Re: Agnico Eagle Mines – Whale Tail Project Responses to South Channel and Road 24 Design Report Comments

- CIRNAC – August 20th, 2019: Crown-Indigenous Relations and Northern Affairs Canada (CIRNAC) comments on Agnico Eagle Mines Limited's (AEM's) South Whale Tail diversion Channel Design Report – Whale Tail Pit Project under AEM's Type "A" Water Licence No. 2AM-WTP1826.
- DFO – August 21st, 2019: Fisheries and Oceans Canada's comments regarding Licence No. 2AM-WTP1826 South Whale Tail Diversion Channel and Road 24 design reports.

Figure 4-5: Flood Routing IDF – Channel 5.0 m Width

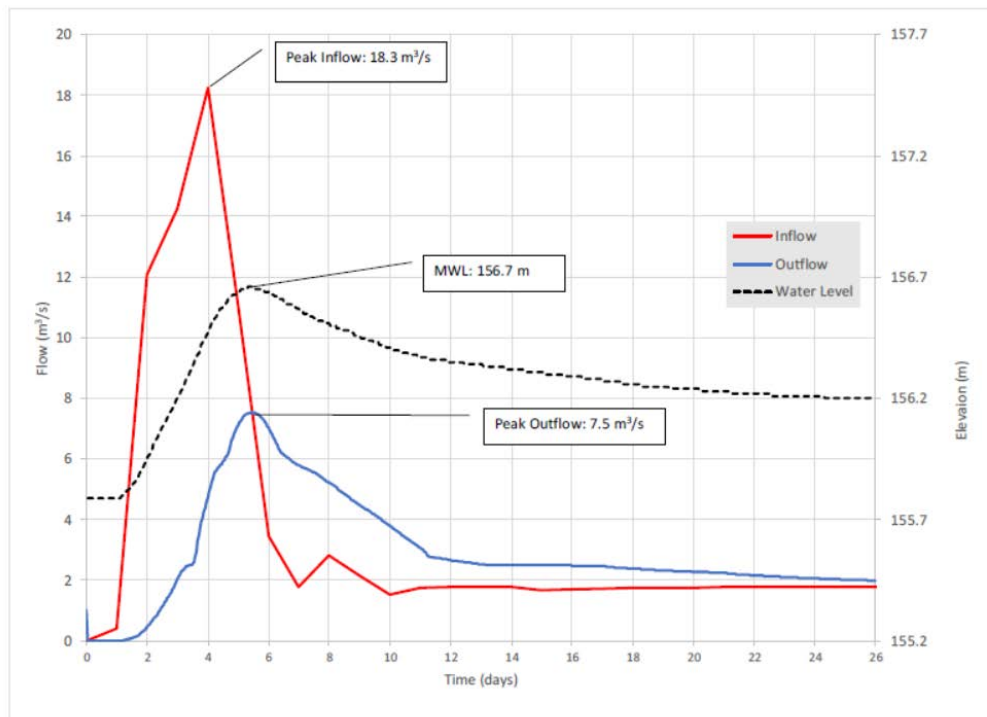
Comment 1: DFO-FFHPP is submitting comments regarding concerns with the inconsistent reporting of water levels and associated assessment of effects on downstream watercourses and waterbodies (see details below). DFO-FFHPP references the ongoing and concurrent NIRB and NWB assessment

Recommendation 1: DFO requests clarification on why the Design Report appears to contradict the statement: "there are no water management scenarios where 156.00 masl will be exceeded" given the maximum water level indicates 157masl is a possible scenario. DFO also notes that in their response to Information Requests submitted to NIRB February 21, 2019 (IR DFO-6) AEM states: "There is no expected change in surface area (hectares) for the South Basin of the Whale Tail Lake, nor any additional surrounding streams, ponds, and lakes will be affected." It is unclear to DFO how an increase of 1m (from 156 to 157masl), and the associated estimated active volume (4.0Mm³) in South Whale Tail Lake may influence downstream water levels and surface areas. DFO also asks for clarification on the difference in South Whale Tail Lake total lake area (ha) when an increase from the normal operating water level of 156masl to the maximum water level of 157masl occurs.

The design flood routing of South Whale Tail Channel indicate that the water level of the South Basin would reach a maximum elevation of 156.7 m during the design flood and would be over the maximum normal operational level for more than a month (Figure 4-5 of Report Client ref. AEM-651298-2900-40ER-01). This design flood elevation does not represent the normal operating level of Whale Tail South Basin. The peak of the design flood event represents an increase Whale Tail South water volume of 3 Mm³ and an increase in area of 44 Ha.
